1 Comment

2 D2.3 (#111, #131, #181, #322, #214, #333, #369).

16 145.2.8.5.1 PSE PI pair-to-pair effective resistance and current unbalance

39 **Figure 145A-2** – Common mode Pair-to-pair channel resistance unbalance

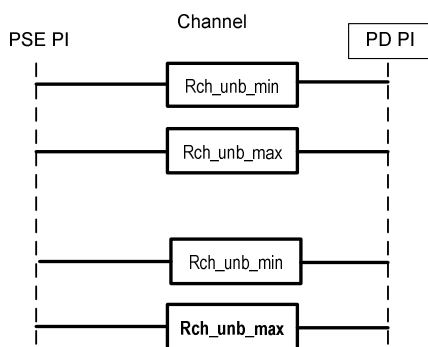
30
 31 Channel ~~C~~common mode resistance is the resistance of the two conductors ~~wires in a pair~~ (including
 32 connectors) in a pair, connected in parallel.

33
 34 The resistance of the common mode pairs of conductors and connectors Rch_unb_min and Rch_unb_max are
 35 described by Figure 145A-2.

Figure 145A-1—Direct measurements of effective RPSE_max and RPSE_min

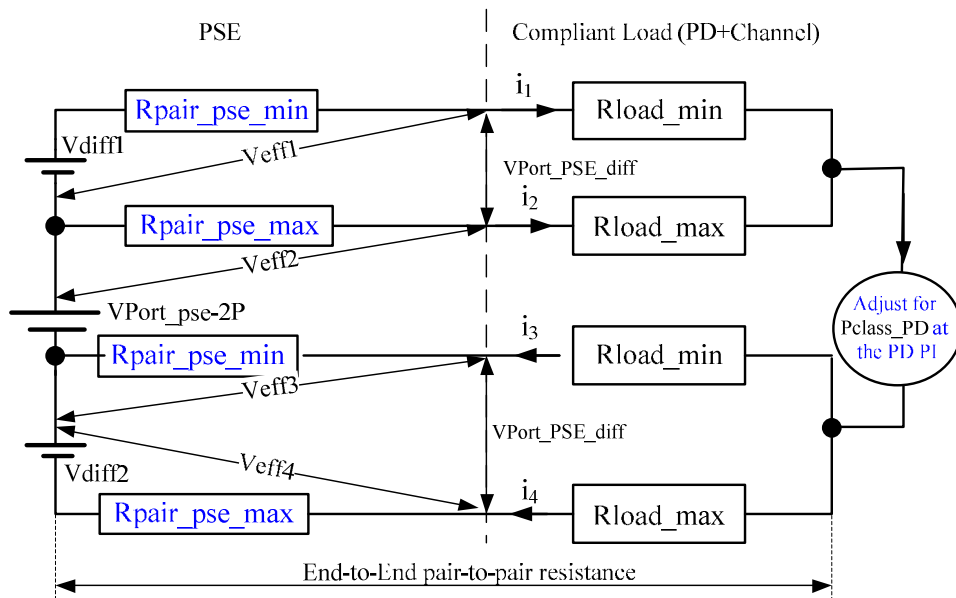
32 [RPSE_{min} and RPSE_{max} values respectively may be diferent than Rpair_pse_min and Rpair_pse_max](#)
33 [values.](#)
34

35 **Update Figure 145A-1as follows:**

36 **Change Rpair_{min} to Rpair_pse_{min}**

37 **Change Rpair_{max} to Rpair_pse_{max}**

Figure 145–34— I_{Con-2P} and $I_{Con-2P-unb}$ evaluation model

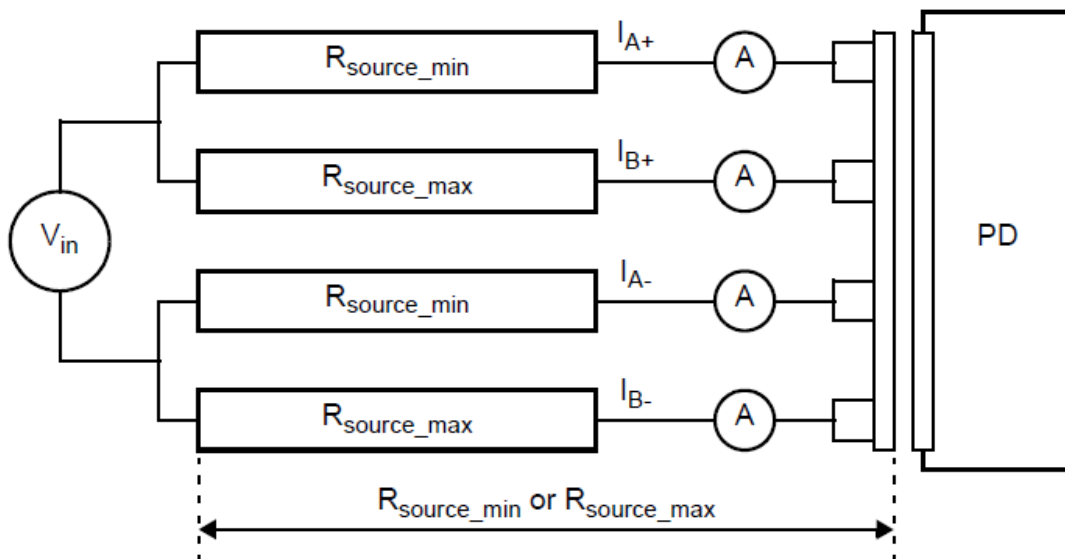
[Note 1 was changed to address comment #322. Note 2 cannot be changed]

NOTE 1—Rsource in Figure 145-34 includes the connecting hardware resistance R_{con} of the evaluation model to the PD which is the connection resistance at the PD. The maximum recommended value is R_{con} value is 0.02 Ω .

Figure 145X-1—PD resistance unbalance elements overview

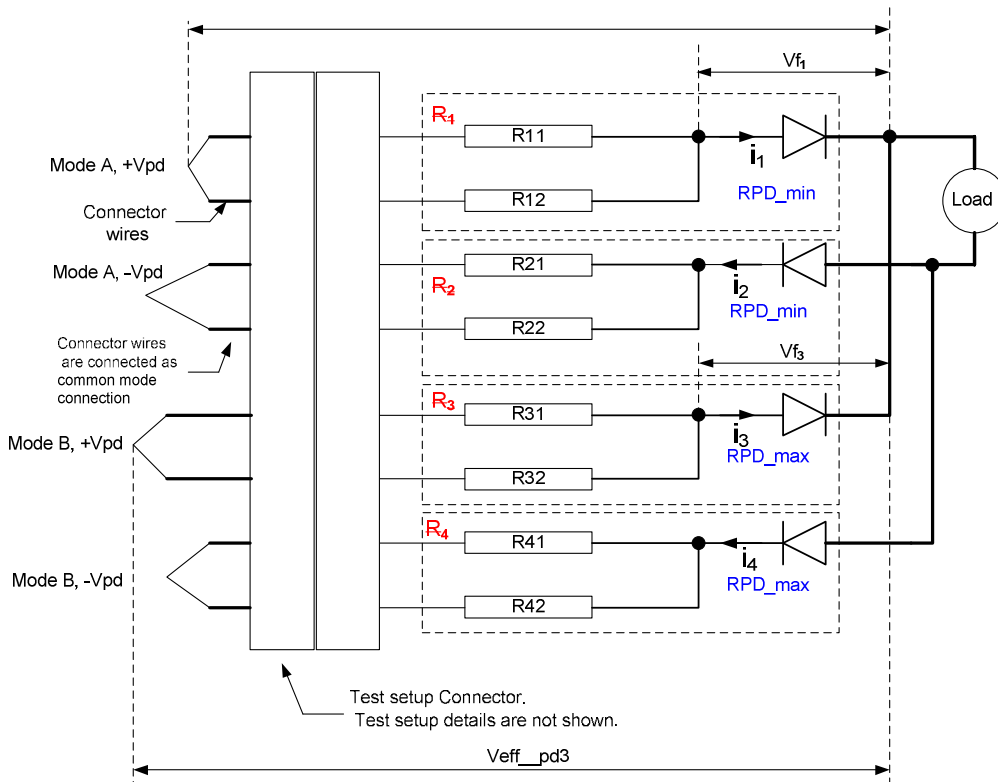
-The following is darshan_05_0116Rev005.pdf with new updates for D2.3 regarding using RPD_min/max instead of Rpair_PD_min/max in the text and in the drawings.

- 1
- 2 -Copy the following text and drawing into Annex 145X (used to be Annex 33A.5 in D2.2).
- 3 -Approved Changes in Figure 145X-1 from D2.2 to D2.3 are marked with RED color.
- 4 -New Changes in Figure 145X-1 from D2.3 to next draft are marked with BLUE color.
- 5

RPD_max and RPD_min represent PD common mode input effective resistance of pairs of the same polarity.

Common mode effective resistance is the resistance of two conductors of the same pair and their other components connected in parallel including the effect of PD pair-to-pair voltage difference of pairs with the same polarity (e.g. Vf1-Vf3). The common mode effective resistance R_n is the measured voltage $V_{eff_pd_n}$, divided by the current through the path as described below and as shown in the example in Figure 145X-1, where n is the pair number.
